# **Final Environmental Assessment for the Southern California Metroplex Project**

Design and Implementation Team  
Technical Report  
Southern California Metroplex Project  
Proposed Final Design Packages  
Executive Summary

## **LAX IRNMN STAR (SYMON)**

Figure 3-2 LAX Arrivals - CLIFY Waypoint Adjustment

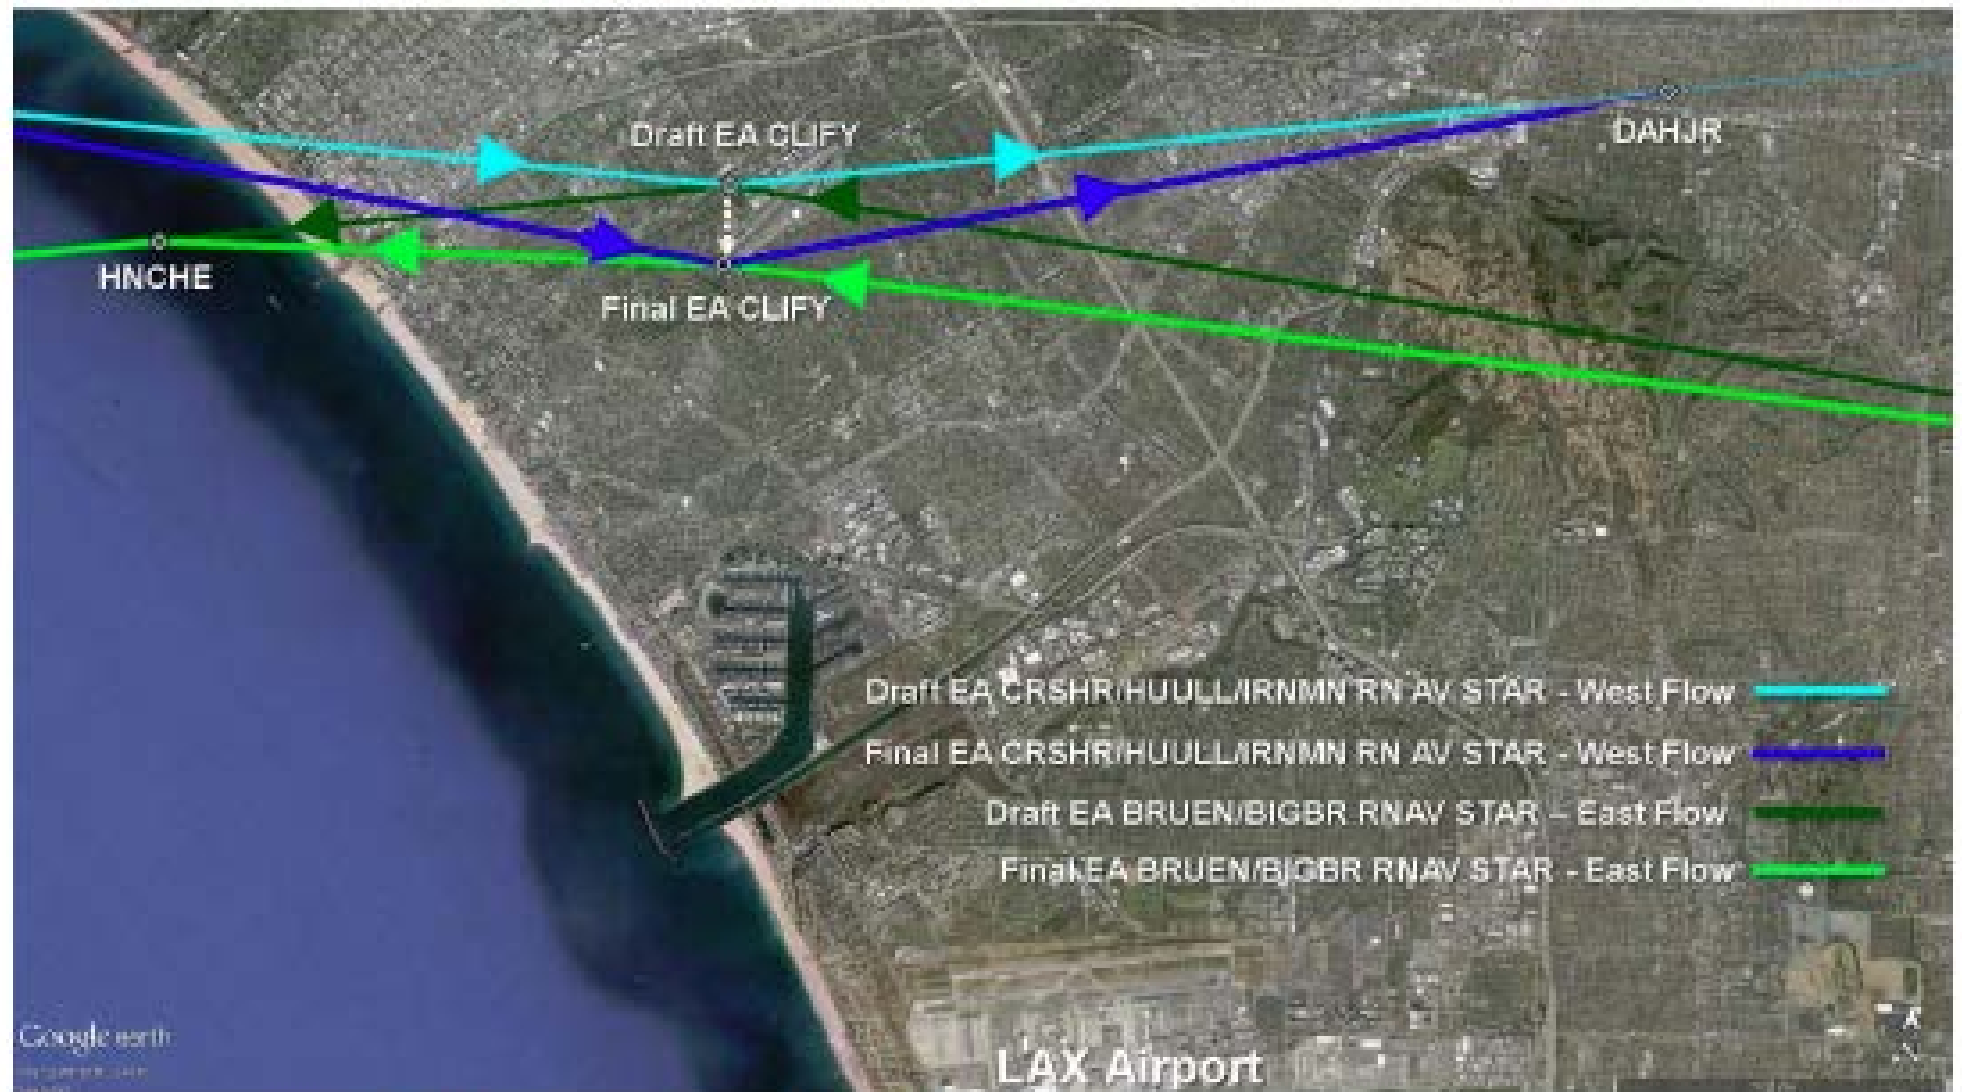
In the main body of the Final EA, page 3-39, this is the only representation of the North Arrival Route.

**It shows STAR CRSHR, HUULL & IRNMN, and it shows these STAR RNAV procedures end at DAHJR.**

**No mention of RNPs or dependency on RNPs.**

## LAX-HHR IRNMN1 STAR West Flow (New)

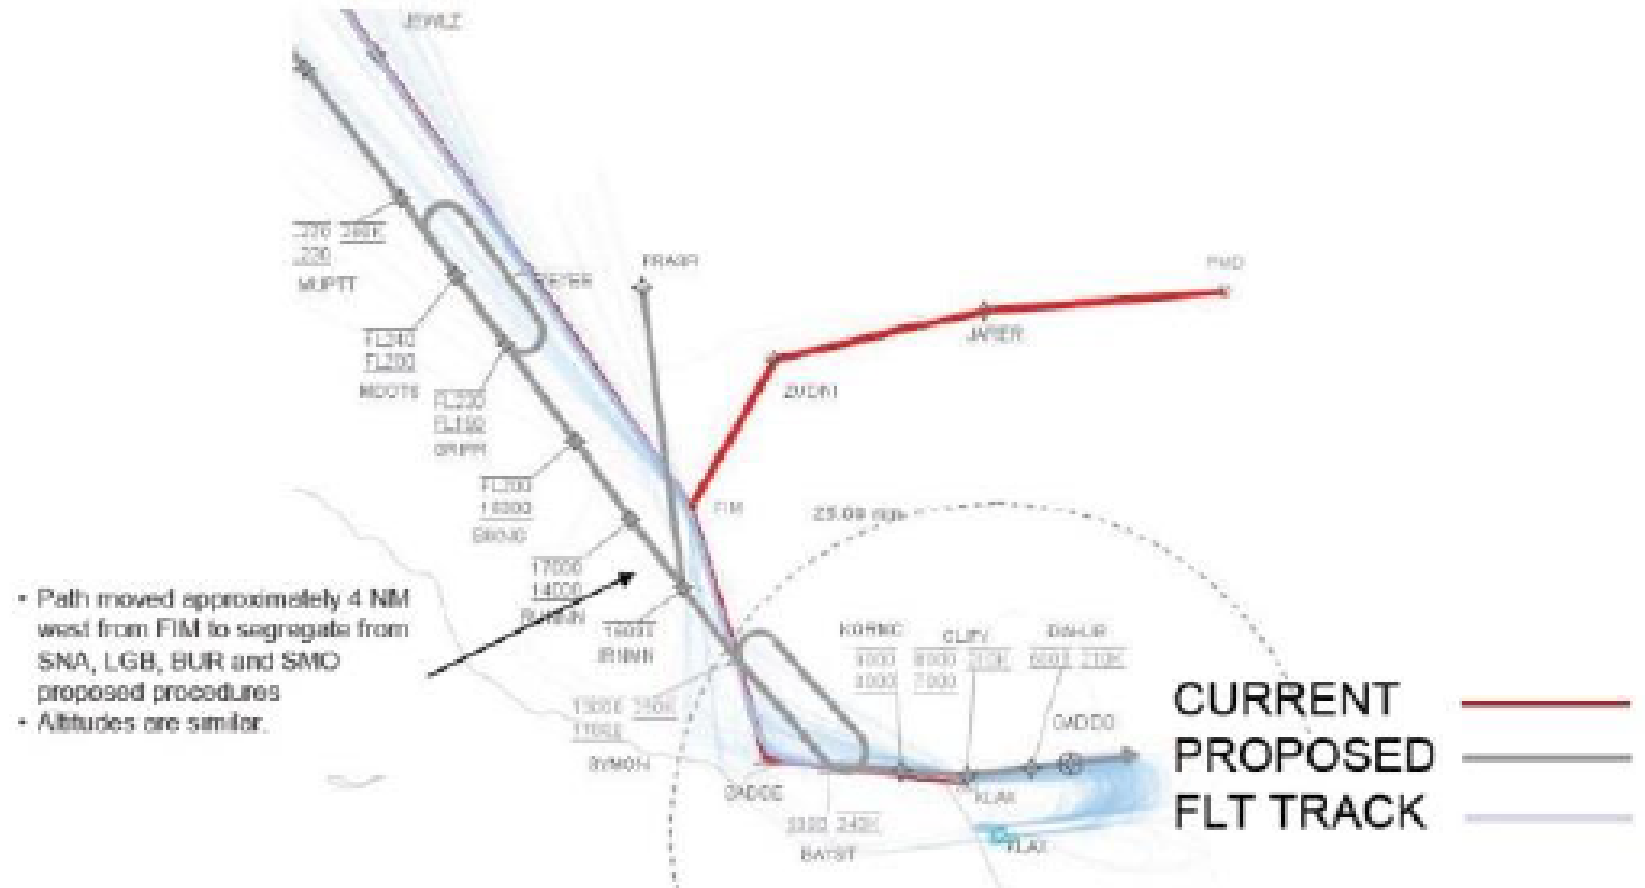
Final EA, Appendix A, p A-407, from June 10, 2015 Draft EA briefing. This is the latest briefing slide show contained in the Final EA, Appendix A.

**Note that the chart shows STAR IRNMN with an AT 6000 Min Alt at DAHJR and it shows the procedure carrying on past GADDO.**

Charts for CRSHR (which became RYDRR) and HUULL are similar.

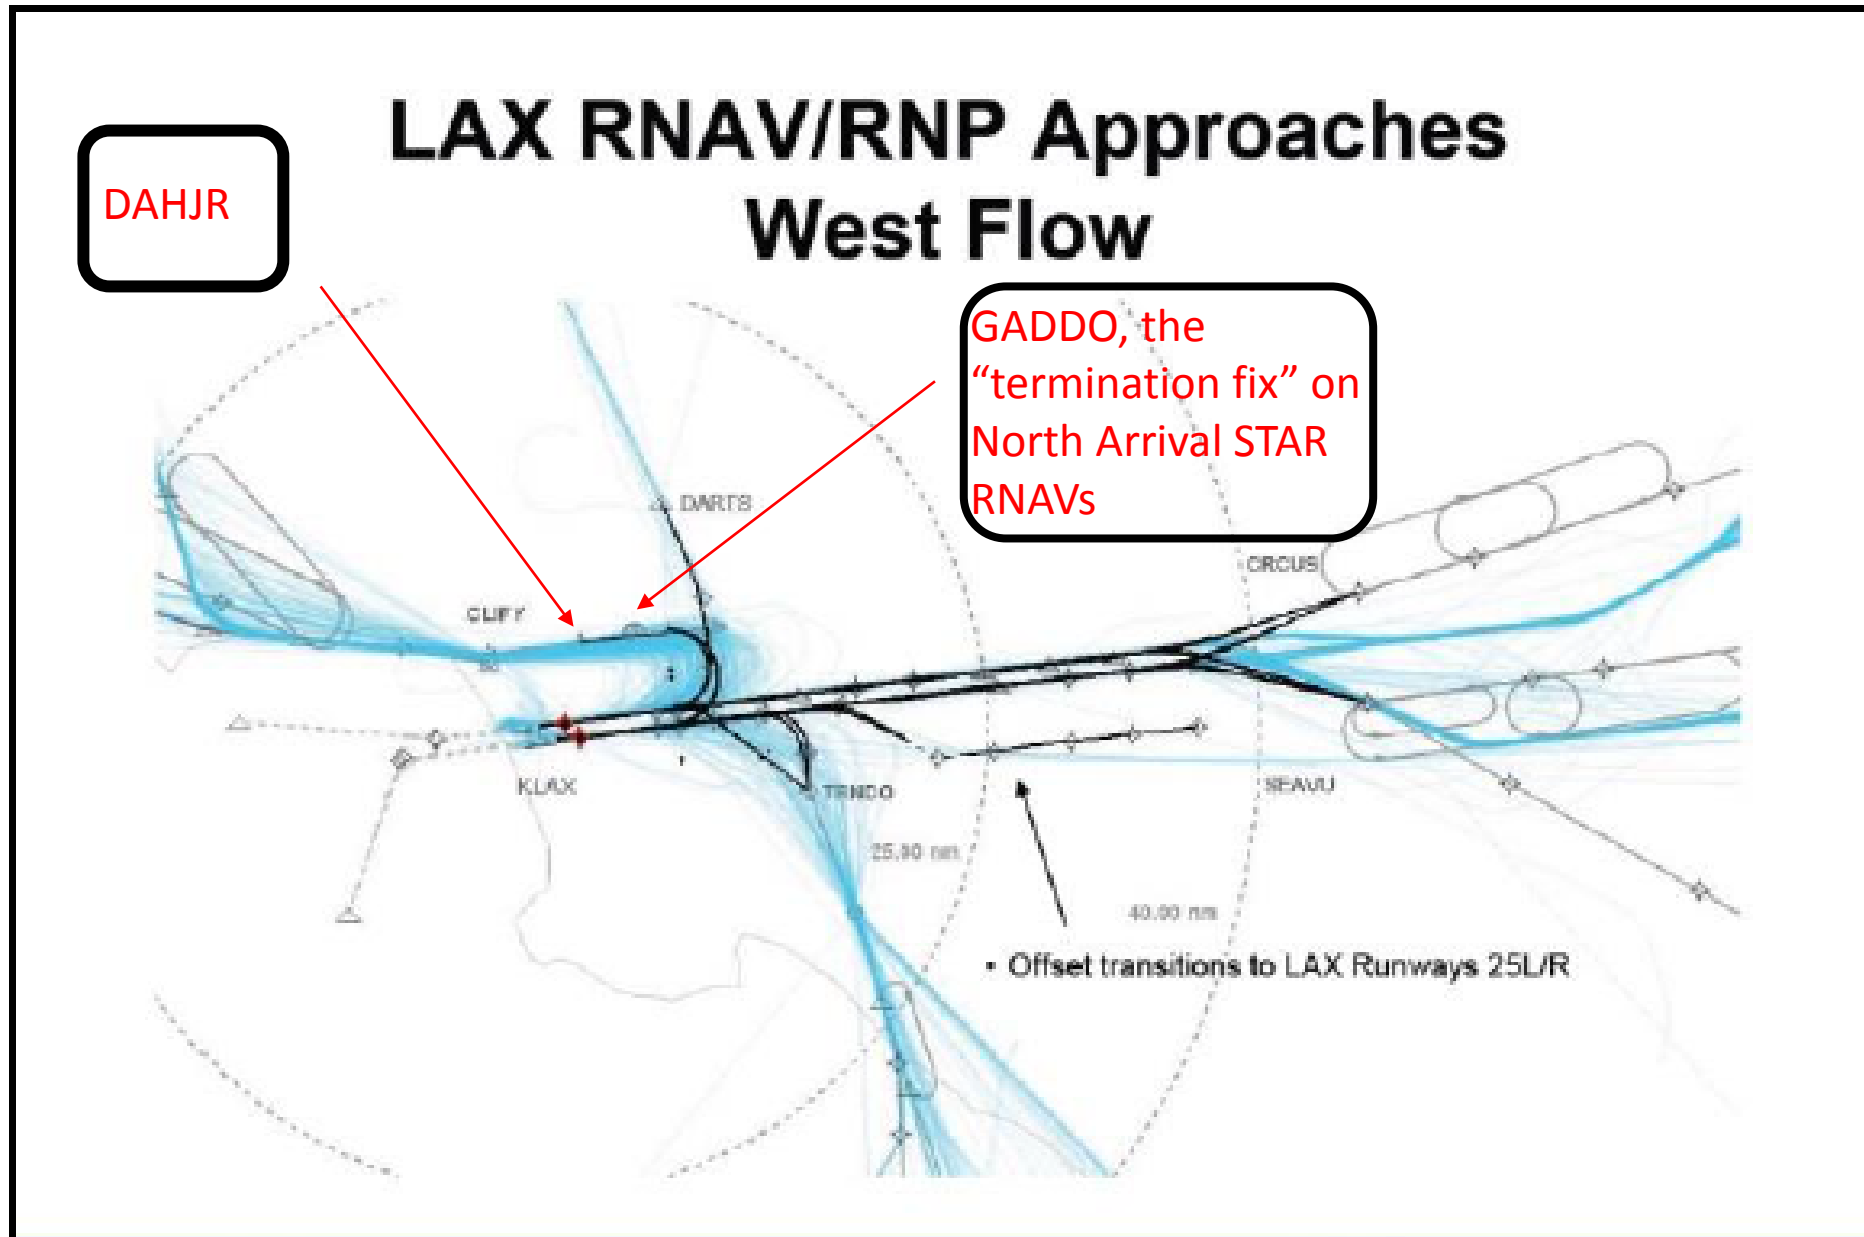
This is the only chart for West Flow RNP approaches.

**Note that the chart seems to show the RNP beginning after GADDO, and certainly no earlier than DAHJR.**

**Note there is no caption and no indication that the Altitude Restrictions in STAR RNAV procedures depend on the aircraft flying the RNP approach.**

### Proposed LAX West Flow STARs

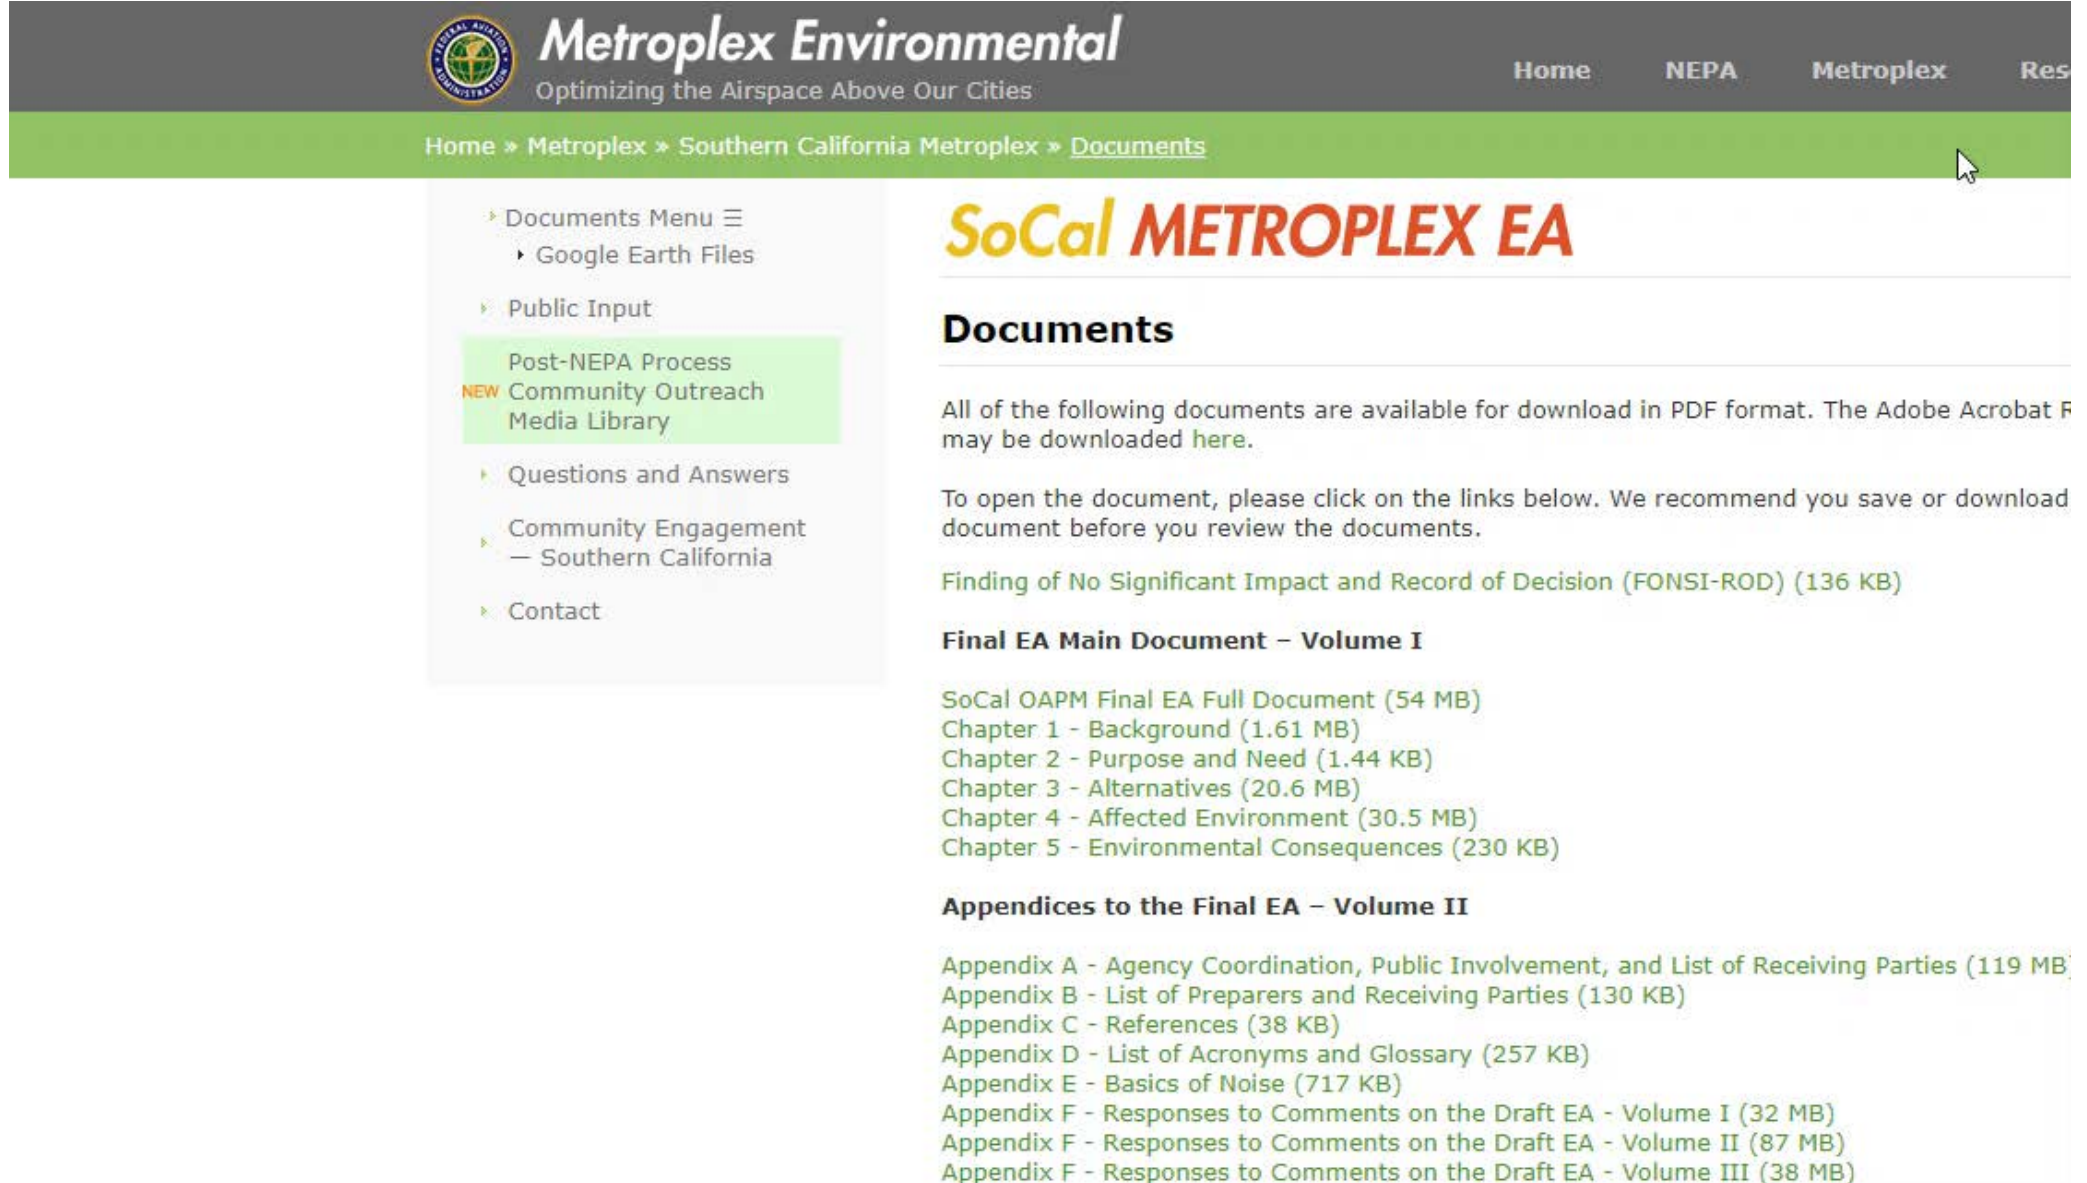
**Something changed between September 2016 and January 2017.**

**On January 18, 2017, in a new webinar, the same FAA Staff who were part of the September 2016 briefings gave a new briefing in which, for the first time, the FAA stated that the Min Alt at DAHJR would only apply to aircraft on the RNP approach, and that aircraft would descend onto visual or instrument approaches from CLIFFY.**

**This was completely different from all representations made during the Environmental Assessment and in the September 2016 briefings.**

**What changed?**

**The “Design and Implementation Team Technical Report” said the implementation of the STAR RNAVs would be dependent on new TRACON SOPs. Was that part of what happened?**

Improving Arrivals into LAX

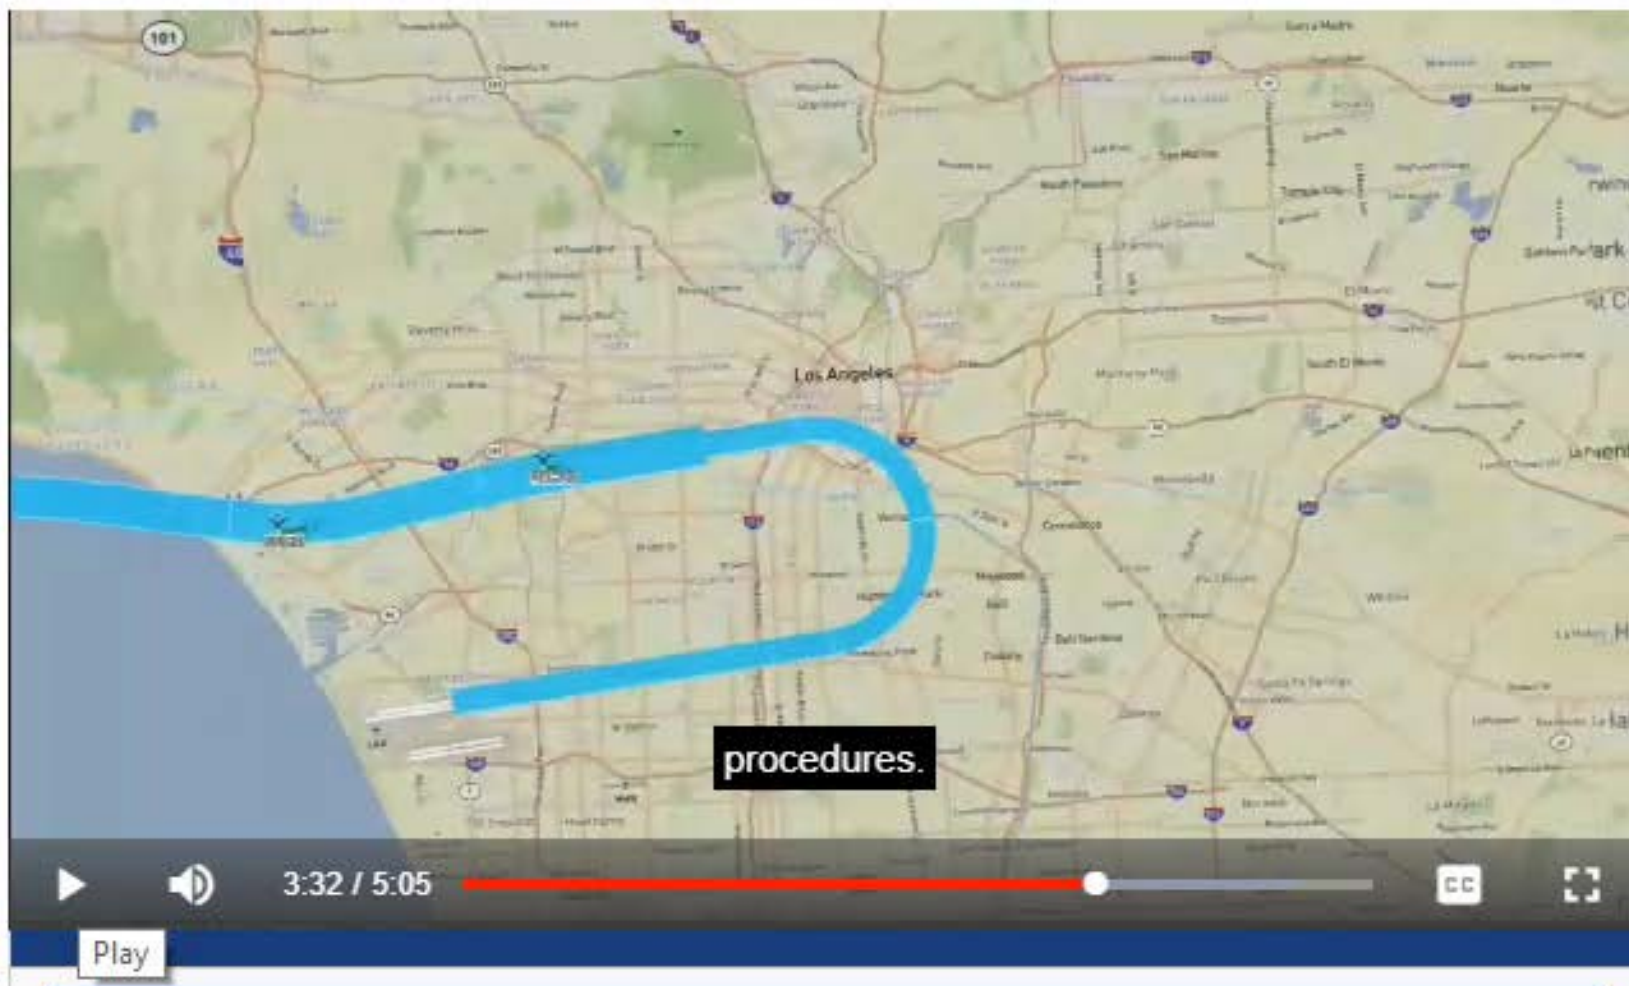
**Despite the new plan briefed in the January 18, 2017 webinar that linked the Min Alt at DAHJR to the RNP approach, the FAA continued to release other informational videos in January 2017 that continued to say that all flights would be restricted by the Min Alt at DAHJR and that only after DAHJR would aircraft leave the STAR RNAVs and go on to the RNP or Visual or Instrument Approaches.**
